Device	XMC1400
Marking/Step	EES-AA, ES-AA, AA
Package	PG-VQFN-40/48/64, PG-LQFP-64, PG-TSSOP-38

Overview

This “Errata Sheet” describes product deviations with respect to the user documentation listed below.

Figure 1 CCU8 simplifier PWM generation scheme - a) normal mode; b) asymmetric mode

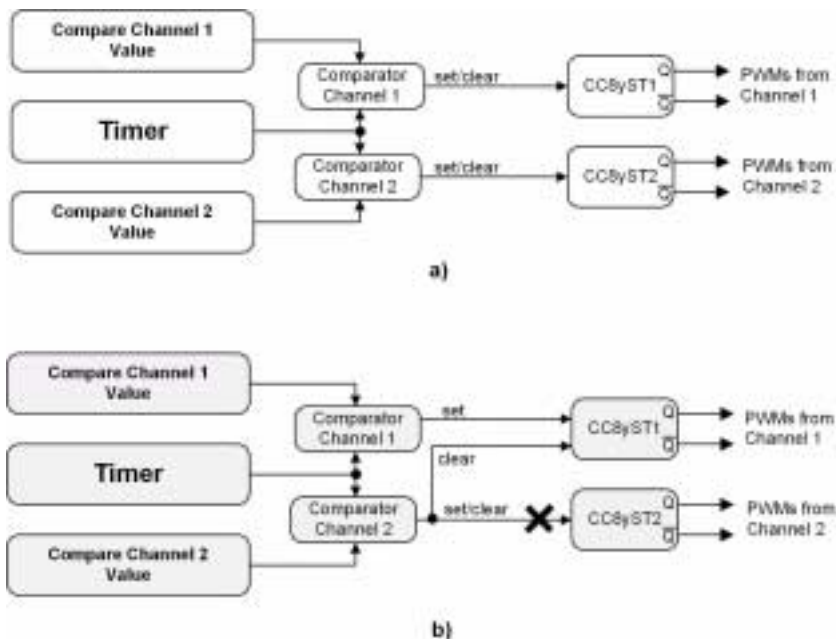
The asymmetric mode has a bug, where the PWM signal of Compare Channel 2 is not stored in CC8yST2. This means that from the Compare Channel 2 the timer cannot generate any PWM signal - depicted by the cross on **Figure 1 b**).

None

Figure 2 CCU8x concatenation feature resource configuration - a) without external count function; b) with external count function

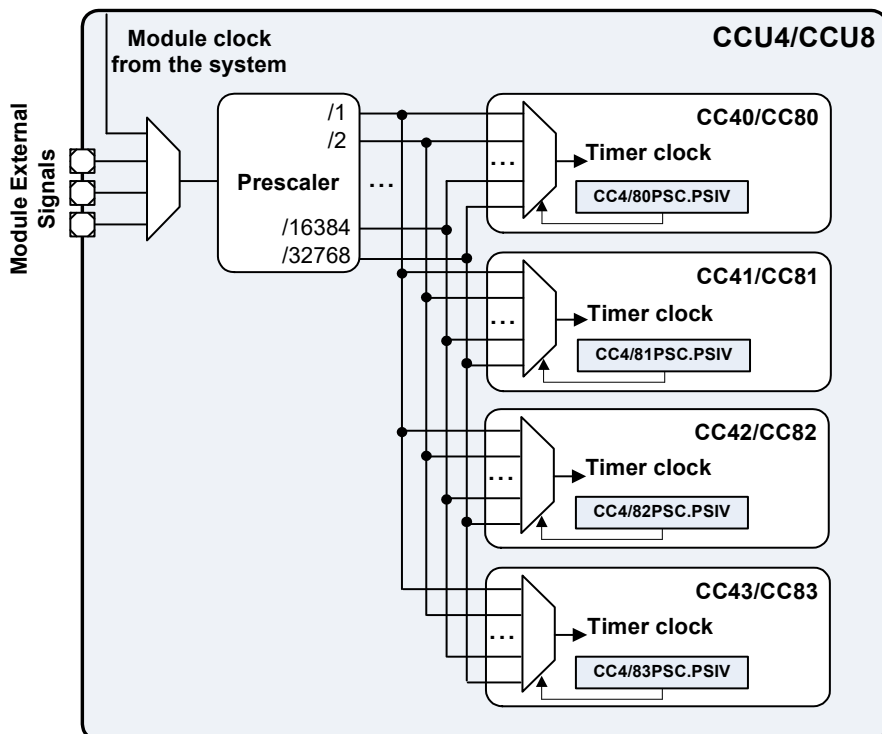
When an external count signal is enabled - by programming the CC8yCMC.CNTS with 01_B , 10_B or 11_B - the concatenation function does not work. One cannot use in parallel the timer concatenation and external count signal features.

Note: On Figure 1, the count signal is used in CCU80 because this timer represents the LSBs. While the count signal could be enabled in the MSB timer (CC81), this does not make sense when the timers are concatenate - because the count should be used to increment the LSB timer. The LSB timer will then in each wrap around, increment the MSB timer.

None
